# Access Compliance Report

## Public Rights-of-Way

Intersection ID: 10031812	Main Street: MILLENNIUM_AV	Cross Street: AUDUBON_PARK_DR	Location:	N
ADA ID: 5A89F3744BCD	Ramp Type: Directional1	Initial Pass/Fail: Fail	Overall Compliance: No	Severity Score: 12.5
Codes/Mitigation Info/Possible Solution		Field Measurements/Component Compliance

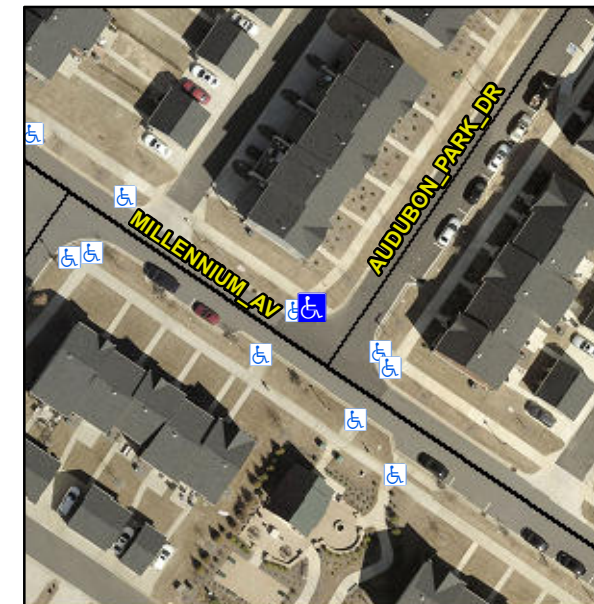
**R304.2.2**

Compliance	Description	Data	Compliance	Description	Data
N/A	Ramp Length (in)	76.0	N/A	Grade Break?	N/A
Yes	Ramp Width (in)	69.0	N/A	Grade Break Slope (%)	0.0
No	Ramp Slope (%)	9.6	N/A	Grade Break XSlope (%)	0.0
Yes	Ramp XSlope (%)	0.1			
N/A	Flare Type LT	N/A	N/A	Flare Type RT	N/A
N/A	Flare Slope LT (%)	N/A	N/A	Flare Slope RT (%)	0.0
N/A	Flare Traversable LT?	N/A	N/A	Flare Traversable RT?	N/A
N/A	Landing Length (in)	0.0	N/A	DWS Provided?	N/A
N/A	Landing Width (in)	0.0	N/A	DWS Contrast?	N/A
N/A	Landing Slope (%)	0.0	N/A	DWS Length (in)	N/A
N/A	Landing X Slope (%)	0.0	N/A	DWS Full Width?	N/A
N/A	Landing Curb? (Y/N)	N/A	N/A	DWS Offset LT (in)	N/A
N/A	Shared Landing?	N/A	N/A	DWS Offset RT (in)	N/A
N/A	Gutter Ponding?	0.0	N/A	Gutter Slope (%)	N/A
N/A	Gutter Lip Ht (in)	0.0	N/A	Gutter X Slope (%)	N/A
N/A	Painted X Walk1?	No		Road Slope (%)	1.2
	X Walk 1 Direction	To SE		Road X Slope (%)	1.3
	X Walk 1 Width (in)	N/A		Clear Space?	N/A

X Walk 1 Slope (%)	1.2	N/A	Clear Space to XWalk (in)	N/A
	X Walk 1 X Slope (%)	1.3	N/A	Storm Grate/Utility Hazard?	N/A
N/A	Ramp inside XWalk1?	N/A		Storm Grate/Utility Type	
N/A	Any Obstructions?	N/A			N/A
	Obstruction Type		Yes	Surface Condition? (G/P)	Good
			N/A	Curb Slope (%)	3.3

**Remove & Replace Entire Ramp.**
